Subject: NHTSA Recall # for Shiver 750 **PENDING**
NHTSA Recall # for Caponord 1200 **PENDING**

Service Communication:  **2015-001:** Safety recall campaign for sprocket fastener

Affected Models: Certain range of 2014-2015 Shiver 750 and 2015 Caponord 1200 models.

**Photo
5**

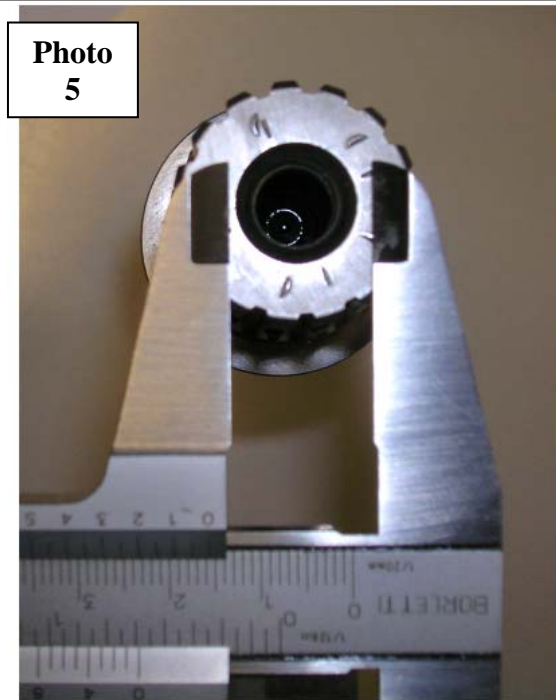
- Measure the outer diameter of the recess on the end of the secondary shaft as shown in photos 4 and 5. **Note: For the procedure to be effective, the measurement must be made with absolute accuracy.**

To reduce measurement error, set the calliper to 15.5 mm and lock in this position, then check if the two jaws of the calliper are inside (photo 4) or outside (photo 5) the diameter of the recess on the end of the output shaft.

If the diameter of the recess is equal to or less than 15.50 mm, clean the thread on the shaft thoroughly following the procedure indicated below:

If the recess is larger than 15.50 mm, select the coupon “**Diameter recess check – secondary shaft replacement**”. Please order the correct secondary gearbox shaft (P/N **849301** for 750 cc engine and P/N **876561** for 1200 cc engine) and the revised sprocket fastener kit, P/N **2R000246** (pre-coated screw, P/N B043047, Belleville washer P/N 2B002193, bush P/N 2B002191). Refer to the engine section of the workshop manual for the procedure relative to Coupon 2 (replacing secondary shaft)
